'Repair and Renovation (Civil, Plumbing, Roofing, Interior, Acoustic, HVAC, Electrical & Solar works) of Auditorium in IMAGE at M.R.C Nagar, Raja Annamalaipuram, Chennai - 600 028'

Clarifications for the queries raised in the pre-bid meeting held at Indian Bank Corporate Office:

Corrigendum of Part-4 (Electrical & Fire alarm works) of Price Bid is as follows:

REVISED SLD (Corrigendum SLD)

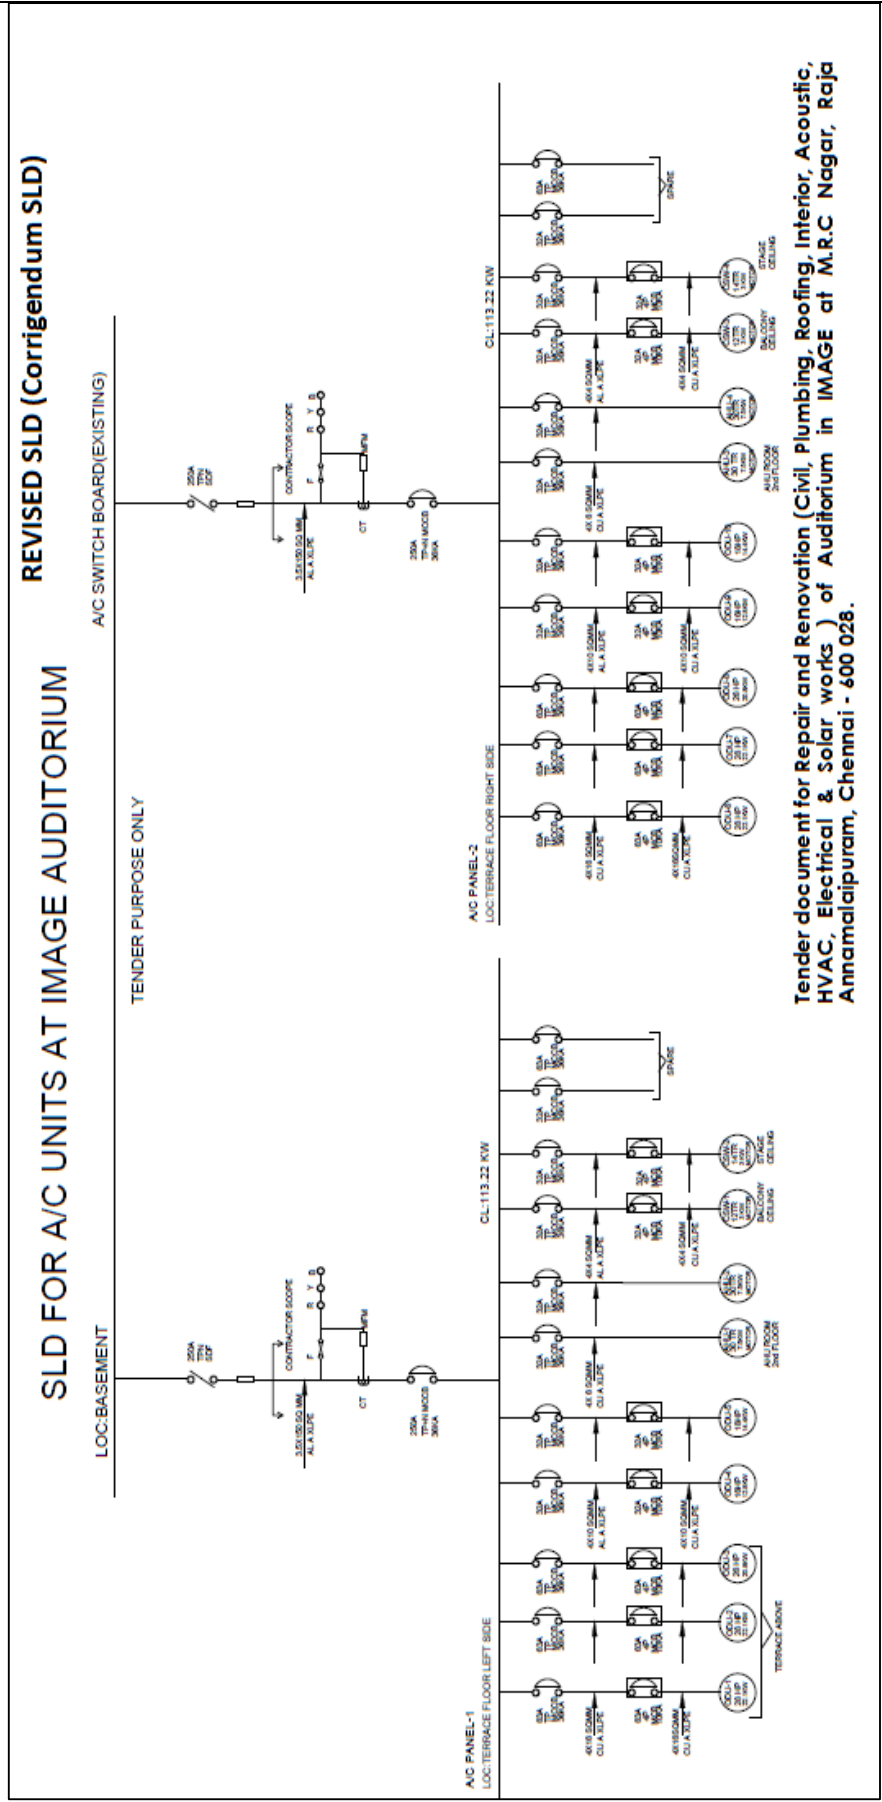
BOQ No.	Page	Description	Corrigendum
4.3.3	73	4-way VTPN DB-2 no	Deleted
4.3.4	74	4-way VTPN DB-2 no	Deleted
4.3.5	75	4-way VTPN DB-2 no	Deleted
4.4.1	75	AC panel 1&2 400A TPN AL bus 400A TP MCCB, 36 Ka incomer CT ratio: 400/5A Outgoing feeders: 4 nos 63A, 4 nos 32A, 1 no 60A and 1 no 200A TP MCCB, 36 kA	250A TPN AL bus 250A TP MCCB, 36 Ka incomer CT ratio: 250/5A Outgoing feeders: 4 no 63A and 7 no 32A TP MCCB,36 kA

4.5.1	76	3.5x240 Sqmm AL A XLPE Qty: 100 Mt	3.5x150 Sqmm AL A XLPE Qty: 100 Mt
4.5.2	76	4x16 Sqmm CU A XLPE along with 2R 10 SWG copper wire from AC panel-1&2 to ODU-1 to 16 panel-1&2 to ODU-1 to 16 Qty: 100 Mt	4x16 Sqmm CU A XLPE along with 2R 10 SWG copper wire from AC panel 1&2 to ODU-1,2, 3,6,7,8 Qty: 100 Mt

4.5.3	77	4x10 Sqmm CU A XLPE along with 2R 10 SWG copper wire from AC panel 1&2 to VDB-2,5 Qty: 20 Mt	4x10 Sqmm CU A XLPE aong with 2R 10 SWG copper wire from AC panel 1&2 to AHU-1,2,,3,4 Qty: 100 Mt

4.5.4	77	3x2.5 Sqmm CU A XLPE along with 2R 10 SWG copper wire Qty: 40 Mt	Deleted Nil
4.5.5	77	3.5x35 Sqmm AL A XLPE along with 2R 10 SWG copper wire Qty: 40 Mt	Deleted Nil

4.5.6	77	4x4 SQMM CU A XLPE along with 2R 10 SWG copper wire from AC panel 1&2 to AHU-2,3,5,6 Qty: 40 Mt	4x4 SQMM CU A XLPE along with 2R 10 SWG copper wire from AC panel 1&2 to CSU-1,2,3,4 Qty: 100 Mt

4.5.7	77	3.5x150 SQMM AL A XLPE from AC panel 1 & 2 to VDB-1,3,4,6 Qty 40 Mt	Deleted

BOQ No.	Page	Description	Corrigendum
4.6.1	77	3.5x240 Sqmm AL termination Qty: 4 No	Deleted Nil
4.6.2	77	4x16 Sqmm CU termination Qty: 60 No	Qty: 24 No
4.6.3	77	4x10 Sqmm AL termination Qty: 4 No	4x10 Sqmm CU termination Qty: 16 No
4.6.4	77	3.5x150 Sqmm AL termination Qty: 8 No	3.5x150 Sqmm AL termination Qty: 4 No
4.6.5	77	4x35 Sqmm AL termination Qty: 4 No	Deleted Qty: nil
4.6.6	77	4x4 Sqmm CU termination Qty: 8 No	4x4 Sqmm CU termination Qty: 16 No
4.6.7	77	4x6 Sqmm CU termination Qty: Nil	4x6 Sqmm CU termination Qty: 8 No
4.10.1	79	63A 4P MCB in IP-67 enclosure Qty: 2 no	63A 4P MCB in IP-67 enclosure Qty: 6 No
4.10.2	79	32A 4P MCB in IP-67 enclosure Qty: 2 no	Qty:8 No
